PCII Request / Re-assessment

< ME209u-526D >, FCC ID: < QISME209U-526 > granted on < 2015-1-13 >

Differences between the ME209u-526D (LGA) and the ME209u-526D (PCIe)

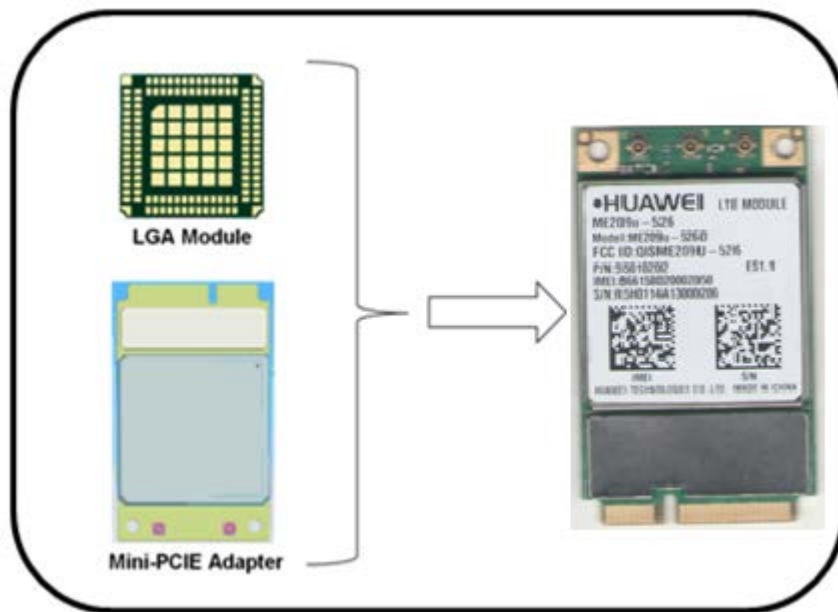
- no hardware changes in RF part
- modification in the host interface as described below

There is the same hardware and software between the ME209u-526D (LGA) and the ME209u-526D (PCIe). The only interface changes from LGA to PCIe.

The new ME209u-526D	The old ME209u-526D
Working bands	The same	The same
Power Voltage	3.0 V to 3.6V (3.3 V is recommended.)	3.3 V to 4.2 V (3.8 V is recommended.)
Interface	PCIe interfaces	145-pin LGA interface
Hardware	The same	The same
